**Re: Vineyard at Cooper Mountain; Phase 2 Design Review; CWS file 18-002050  
(Tax map 1S13100 Tax lots 01600 & 01605)**

# THE VINEYARD AT COOPER MOUNTAIN - PHASE 2 - TOWNHOMES

## AMENDED Service Provider Letter

# Fire Service 'FS1' Exhibit

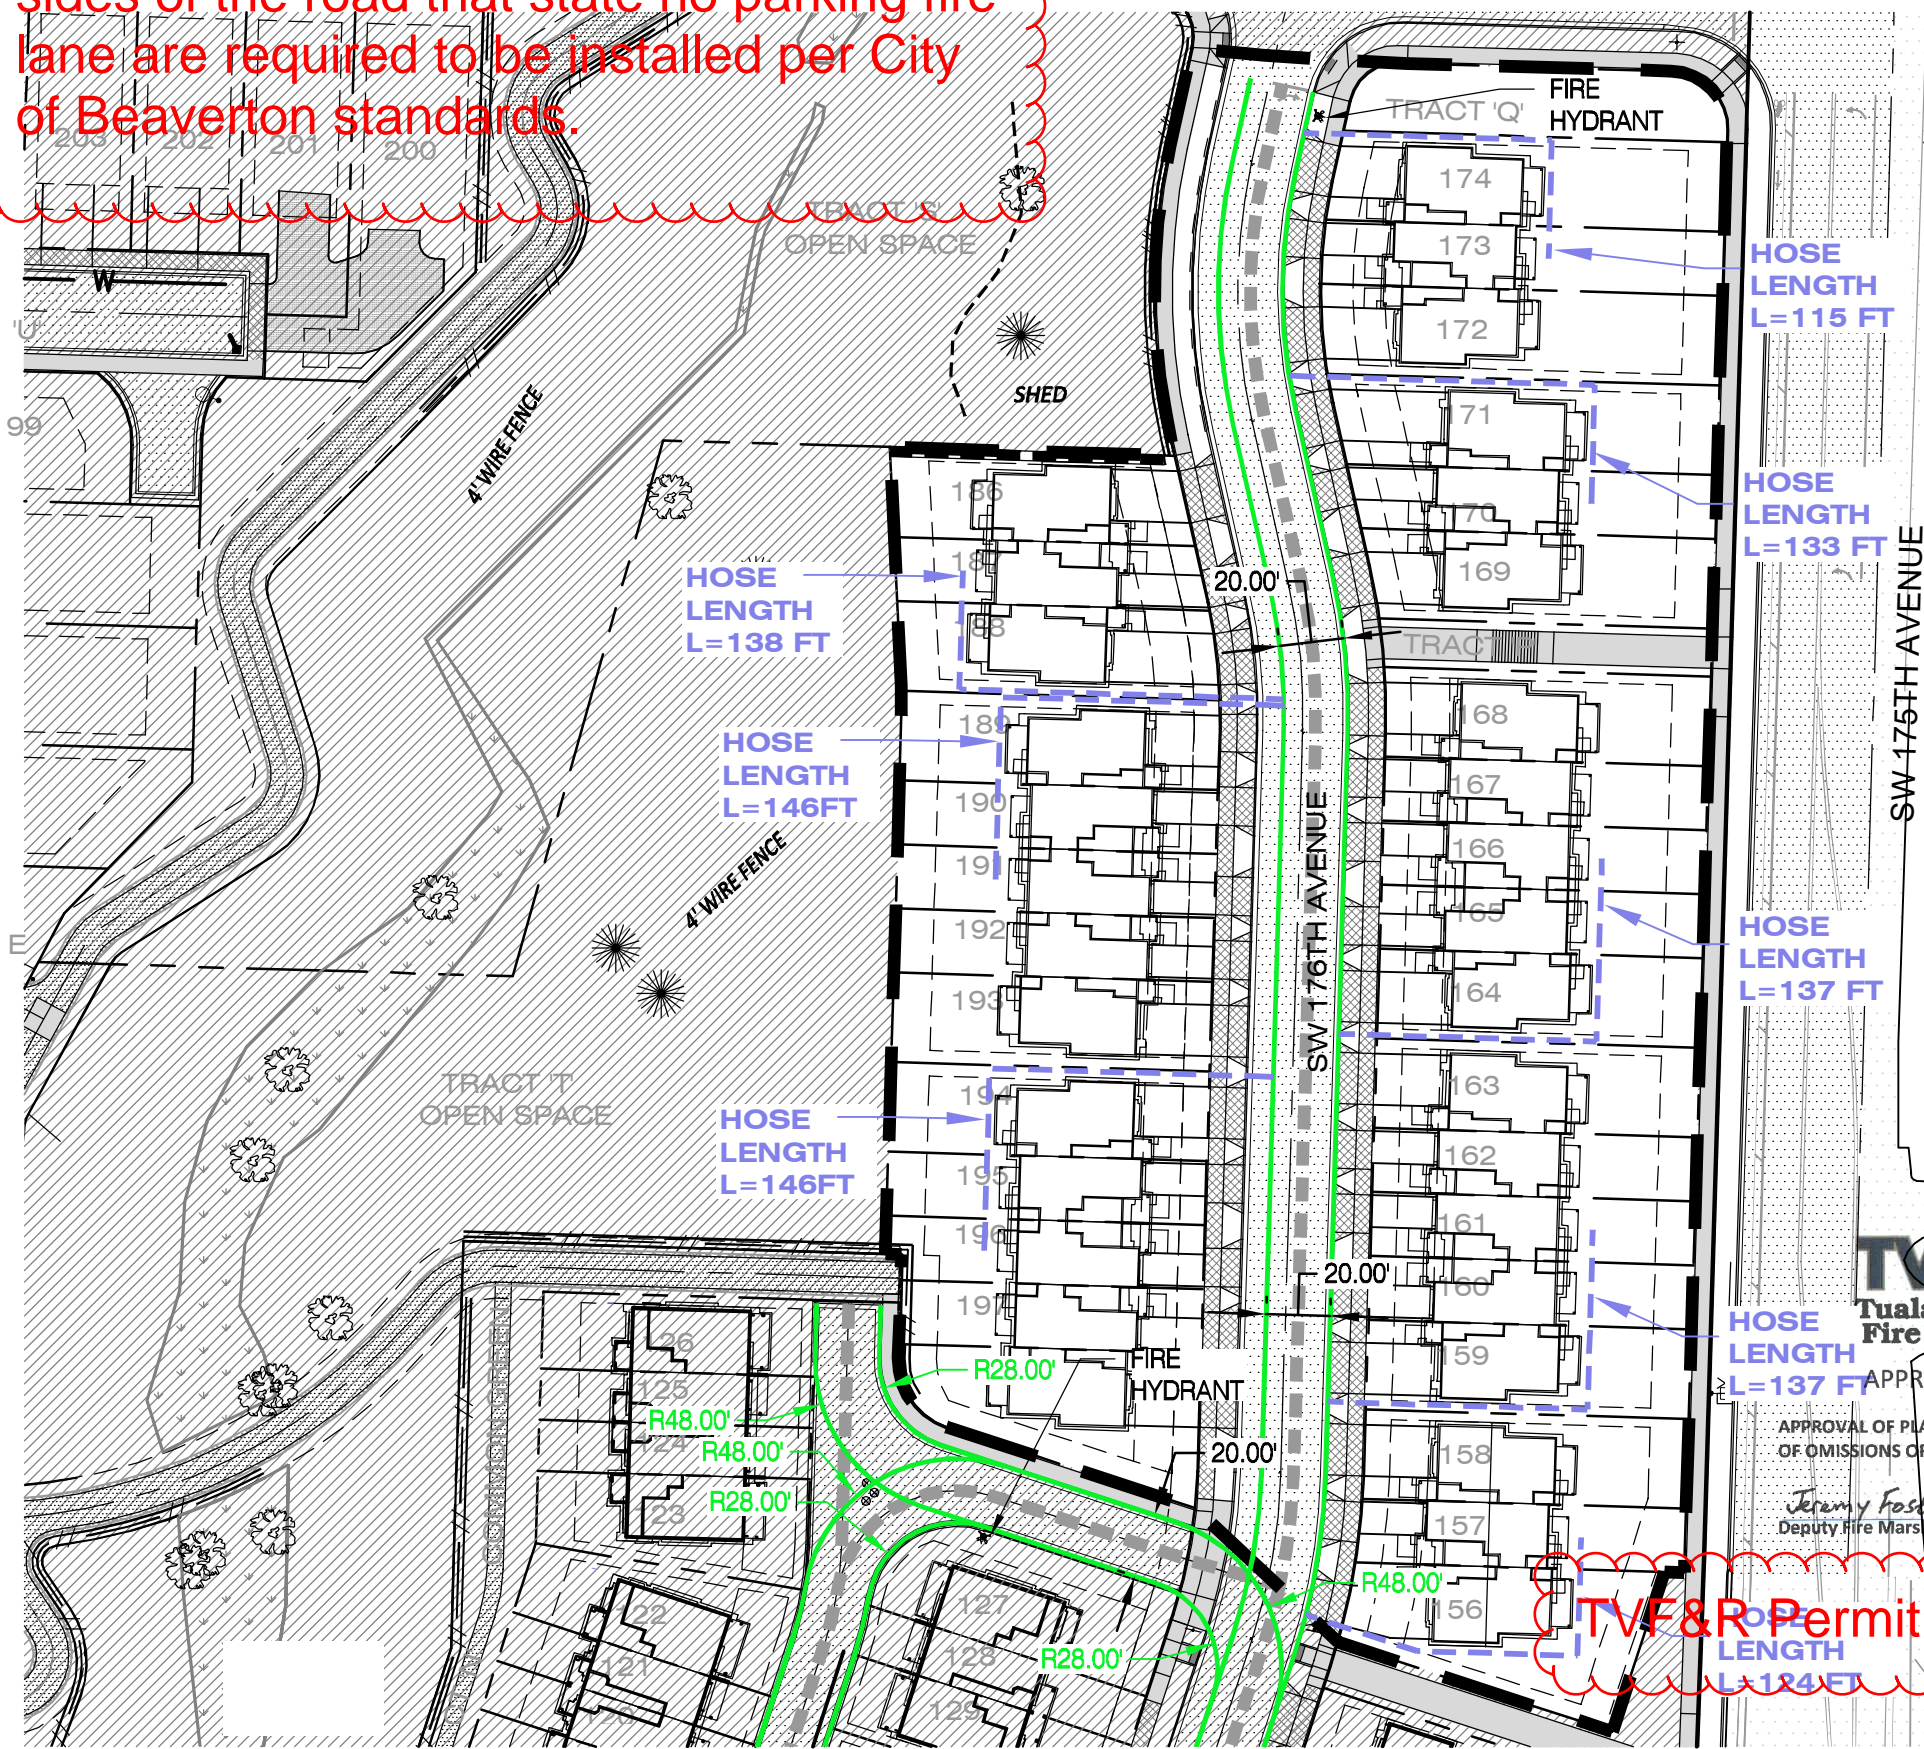
Note: A final inspection from TVF&R is required for this project. Signage on both sides of the road that state no parking fire lane are required to be installed per City of Beaverton standards.
